**SUBJECT:** Calvert Cliffs Nuclear Power Plant  
Unit Nos. 1 & 2; Docket Nos. 50-317 & 50-318  
Supplemental Data for Request for Relaxation from Certain Inspection  
Requirements in NRC Order (EA-03-009) for Reactor Pressure Vessel Head  
Penetration Nozzles (TAC Nos. MB7752 and MB7753)

**RESPONSE TO REQUEST FOR ADDITIONAL INFORMATION AND  
REACTOR PRESSURE VESSEL HEAD UT EXAMINATION RESULTS**

**ADDITIONAL RELAXATION REQUEST**

FIGURE 1

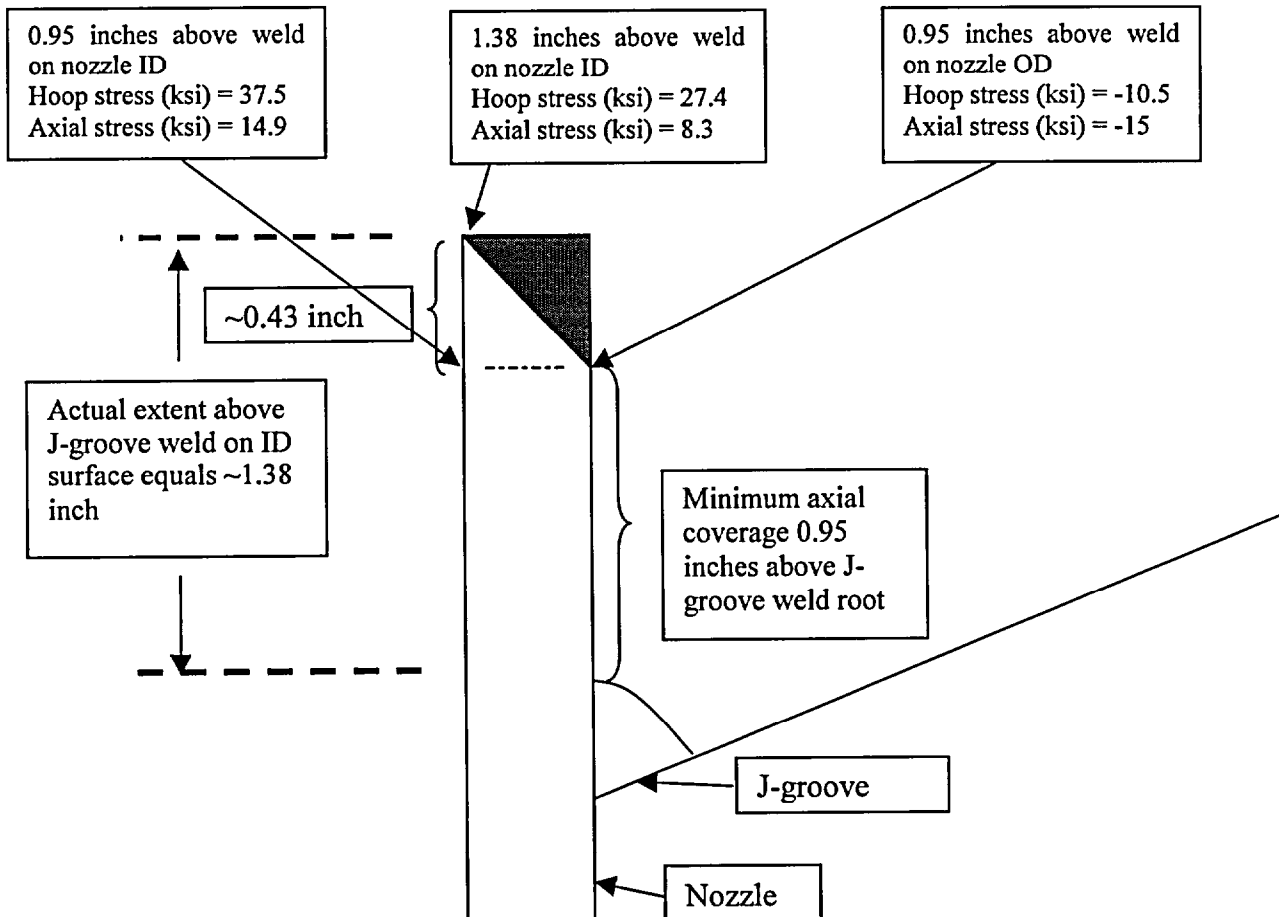
*Provide the bounding hoop and axial stresses present at the location of lowest coverage above the J-groove weld.*

The requested information is provided on Figure 1 below. The bounding value is located on Nozzle 43 which had coverage to 0.95 inches above the root of the J-groove weld. Nozzle 43 has a 38.5 degree angle with the head. Calculated stresses are reported for a 42.5 degree nozzle, which bounds a 38.5 degree nozzle. Stresses are provided at three locations: on the outside diameter (OD) at the elevation of highest coverage, on the inside diameter (ID) at the same elevation, and on the ID at the elevation of highest coverage. Coverage elevations above the J-groove weld have been reported for coverage on the OD. In all cases coverage on the ID is higher. This is due to the configuration of the transducers in the blade probe and is analogous to the situation at the bottom of the nozzle (see Figure 1 in Attachment 2). Further discussion on the configuration of the transducers in the blade is contained in Attachment (2).

Bounding hoop and axial stresses at elevation of minimum coverage extent above the root of the J-groove weld occurs on Nozzle 43
